ISSUE: Permit to Demolish/Capsulate (full) and Certificate of Appropriateness for new construction.

APPLICANT: City of Alexandria, Virginia

LOCATION: Parker-Gray District
1609 Cameron Street

BAR#2026-00120 & BAR#2026-00133
Parker Gray
1609 Cameron Street
(Parcel Address: 1501 Cameron Street)

Photo 1: Concept Design - south elevation.

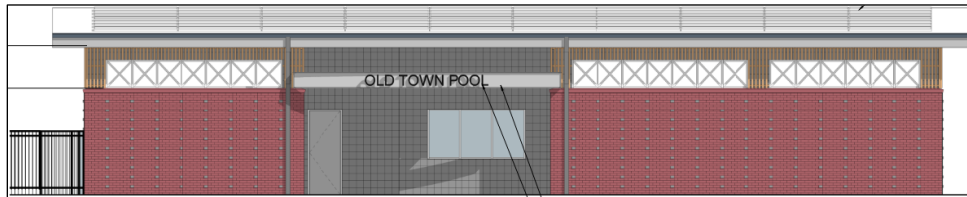
On January 7, 2026, the BAR heard a concept review presentation on the complete demolition of the existing Old Town Pool and the construction of a new bathhouse, pool, and site elements. The applicant has made the following changes to the submission since the last time it was before the Board:

1. The building height now ranges from 17'-4" feet at the north elevation to approximately 14'-10" feet at the south elevation. The previous design had a building height ranging from approximately 16 feet at the north elevation to approximately 14 feet at the south elevation.
2. The proposed bathhouse has been reduced from 5,280 SF to 3,888 square feet under roof.
3. Hardwood slats are no longer a part of the bathhouse's exterior materials.
4. Shade structures were added to the pool deck design.
